APPLICATION NO.	FILING DATE	FIRST NAMED INVENTOR	ATTORNEY DOCKET NO.	CONFIRMATION NO.
09/803,412	03/09/2001	Harry W. Schmidt	T268.12-0047	4806

Office Action Summary

DETAILED ACTION

Figure 3 (partial) of instant invention

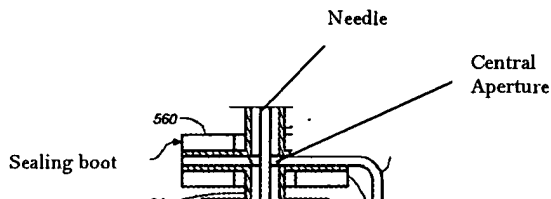
It appears that Applicants rely on their sealing boot (558) in combination with needle block (574) to support their claim of a "seal". However, the needle block feature is not a part of the instant claims. The Examiner understands Applicants' argument that according to the disclosure of Stone and figure 4 of Stone, the vial stabilizer (320) never reaches needle housing (280). However, the needle housing of Stone would be equivalent to the needle block of the instant invention, which is not claimed.

Furthermore, according to the specification, Applicants' sealing boot is depicted by reference character (558), which is shown as a structure disposed about the sampling needle and having a central aperture through which the needle may move. Stone shows the same structure surrounding the sampling needle and having a central aperture through which the needle may

Figure 3 (partial) of Stone

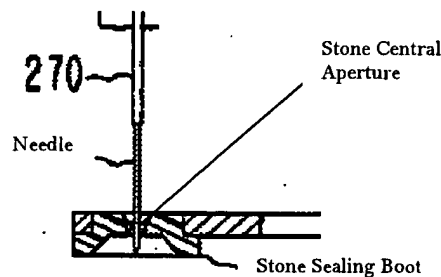
Applicants point to the teaching in Stone that the vial stabilizer has a central aperture allowing it to move freely with respect to the inner and outer needles and assert that this teaching prevents any seal from forming between the vial stabilizer and a vial. It is unclear, however, how Applicants can draw such a conclusion from this teaching. In comparing the instant invention to that taught by Stone, both devices have the structures and operate in the same manner. In the instant invention, there exists an aperture in the sealing boot that will allow the needle (556) to move freely through the sealing boot. Compare figure 2 of instant application, where sealing boot is located at the bottom of the needle to figure 3 of the instant application, where the needle protrude through the sealing boot into the vial. See also, figure 3 of Stone where the vial stabilizer is located at the bottom of the needle and figure 4, where the needle protrudes through the sealing boot and into the vial. Figure 4 of Stone clearly shows that the vial is completely engaged with the vial stabilizer.

move. Thus, although Stone may not disclose the vial stabilizer as a "sealing boot", the structures are the same.
